AirLINE SP

Type 8647 valve island - ready for the future!

Revision 1

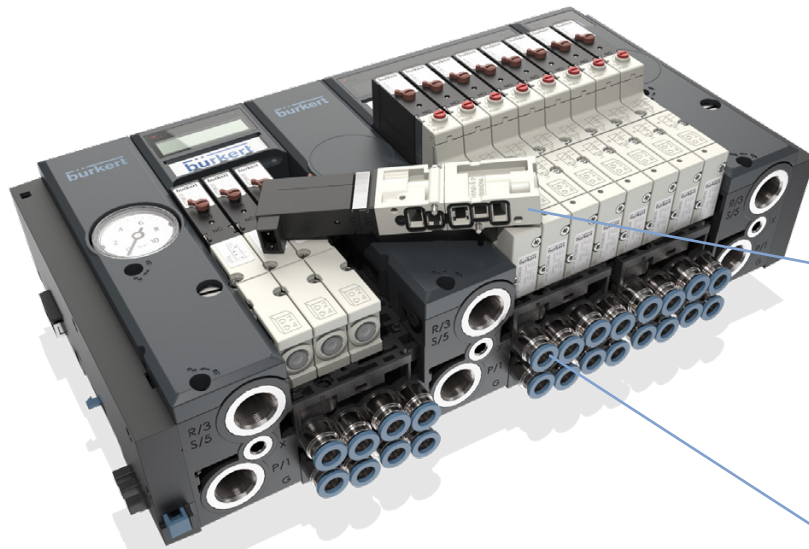
- **Project planning:** software unchanged
- **Dimensions:** unchanged (connections 5 mm longer)
- **Spare parts/compatibility:** due to fundamental optimisation of the pneumatic modules, backward compatibility is not given

Single valves
(Changed connection diagram due to different size of the channels)

Flow rate reduction
(for HotSwap and check valve function)
